# CYPRESS ENVIRONMENTAL AND LAND USE PLANNING

April 22, 2019

## **Subject: Cordoba Center Project – Project Revisions**

Attachment 1- Sheet 1 of 2

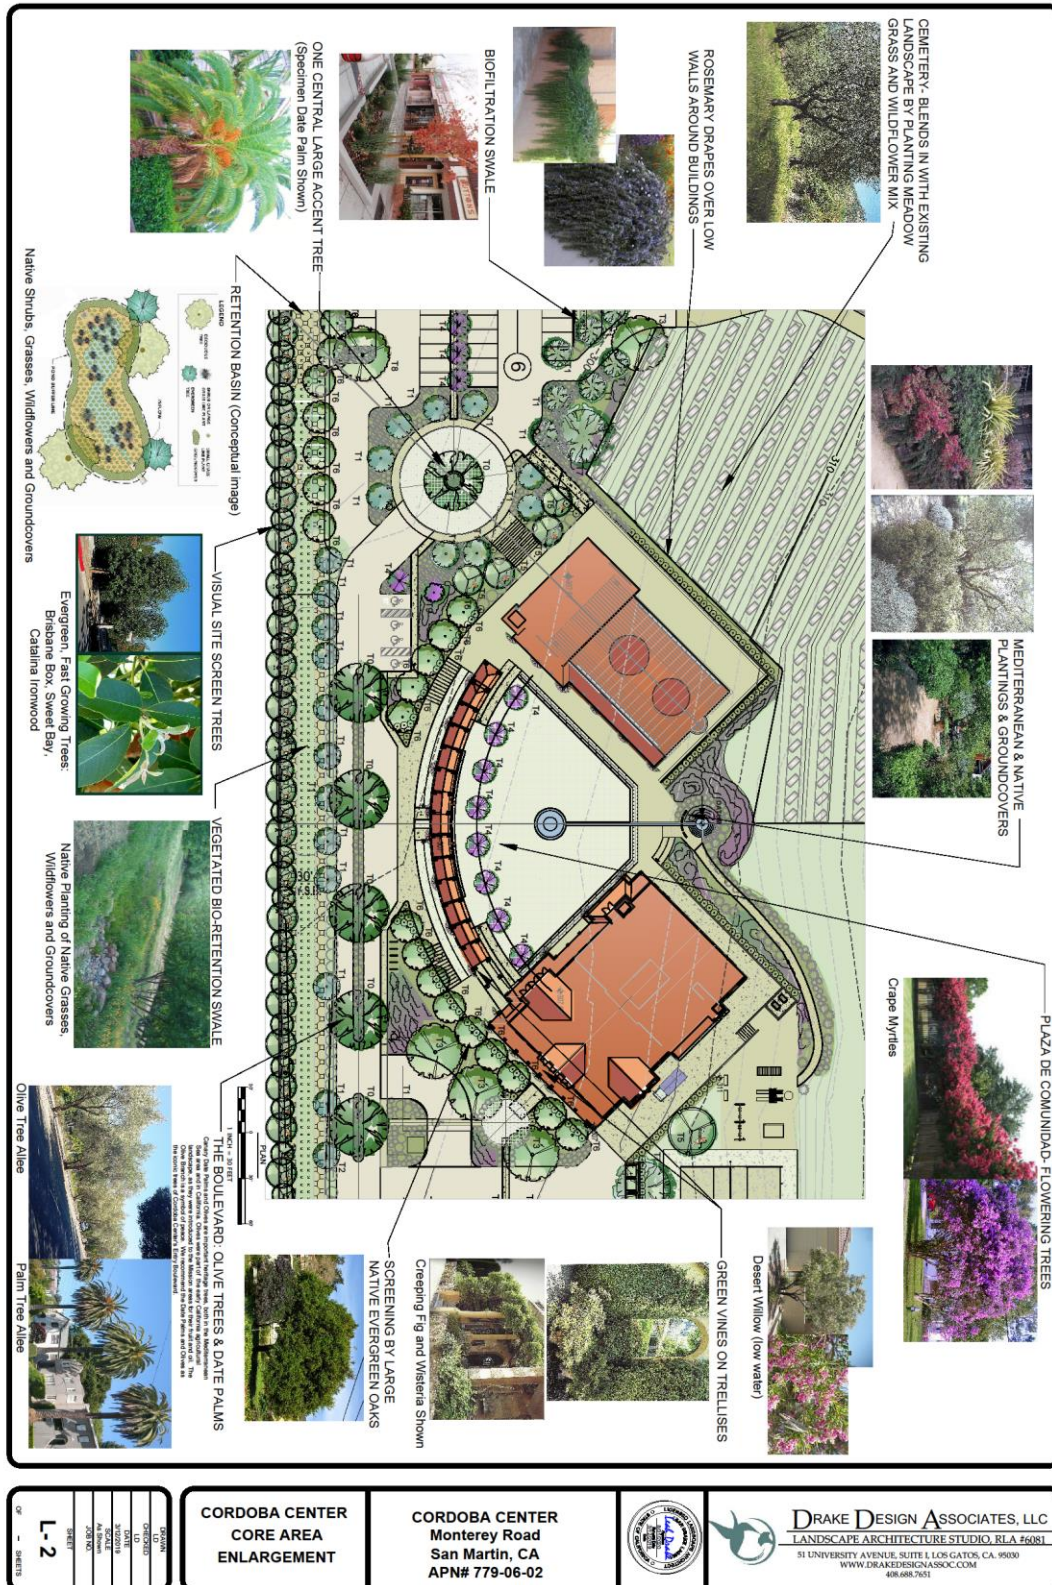
- 1) Provide additional screening along the frontage of Monterey Road by specifying the first three rows of the fruit orchard will be evergreen olive trees (*Olea europa*);
- 2) Add a California Pepper tree (*Schinus mole*), an evergreen, to corner of the caretakers dwelling closest to entry driveway;
- 3) Provide a denser evergreen screen along the south property line by replacing California sycamore trees with three evergreen species - Brisbane Box tree (*Lophostemon confertus*), Catalina Ironwood (*Lyonothamnus florabundus*) and Sweet Bay (*Laurus nobilis*);
- 4) Artfully replace the line of Ceonothus between the campground and the cemetery with indigenous random groupings of Live oak trees and native evergreen shrubs - ceanothus spp., toyon, and

manzanita spp.- for a naturalized appearance, enhanced habitat value, slope stability/erosion control and screening. This revised planting is designed to also screen campground area and water tanks from Monterey Road.

The revised project plan sheets L-1 and L-2, dated March 12, 2019 replace previously submitted sheets L-1 and L-2, dated December 22, 2015. Reduced copies of both sheets are provided as Attachments 1 and 2. Full-size plan sheets and digital copies will be provided with the updated complete project plan set in the next few days. Detailed information about the three tree species now proposed at the south property line is also attached for your reference.

## Attachment 5 - Originally Proposed Site Plan Showing Impervious Area Groupings

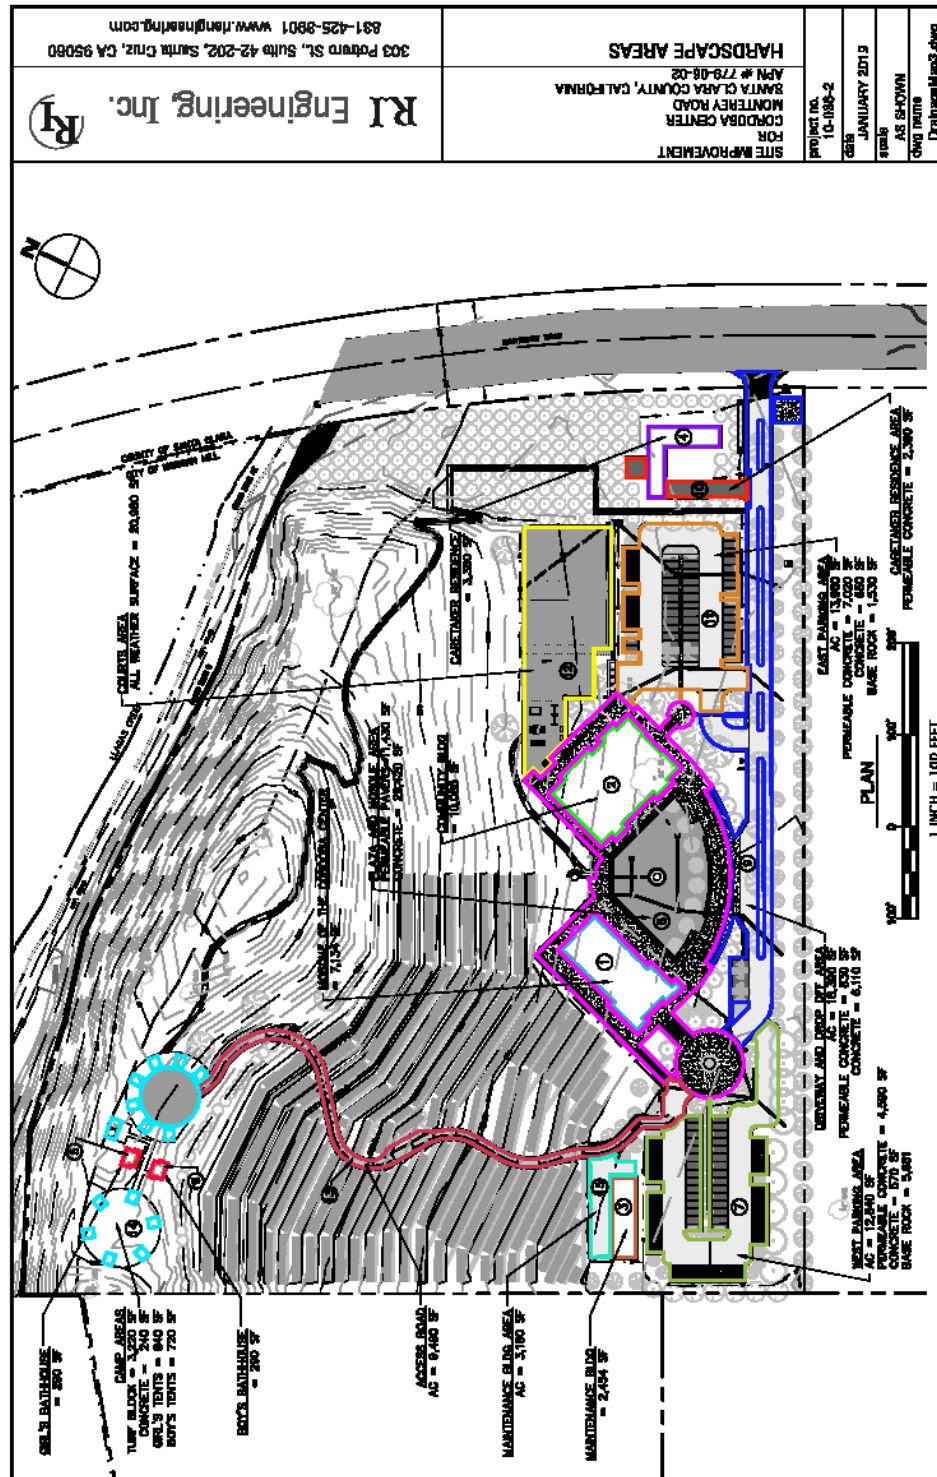
While the Draft EIR did not identify a need to reduce the amount of impervious surfacing included in proposed improvements, I understand County findings pursuant to the Rural Resources Impact Study require minimization of impervious surfaces. Therefore, the project has now been revised to reduce the amount of impervious surfacing from 139,423 sq. ft. (originally proposed) to 95,723 sq. ft. (now proposed). This reduction, which is shown on the attached Excel spreadsheets, makes the project surfacing similar to that of a hypothetical 75<sup>th</sup> percentile project.

The Excel document titled Exhibit A (Attachment 4.a) quantifies the originally proposed amount of pervious and impervious surfacing at developed areas of the project. The other document titled Exhibit B (Attachment 4.b) quantifies in detail the impervious surface converted to pervious surfacing. Exhibit B shows where in the project the converted surfacing will be located and the type of pervious surfacing that will be implemented at these locations in the construction phase of the project. The originally proposed site plan (Attachment 5) is included for your reference. It color codes the surfacing subareas of the project. These are the same subareas as used in the Exhibit A and B documents. This site plan is meant to be an aid when reviewing Attachment 4.a. A revised site plan, showing the reduced amount of impervious surfaces, in accordance with Exhibit B, has also been provided (Attachment 6). It will be included as a full-size plan sheet in the updated project plans to be submitted in the next few days.
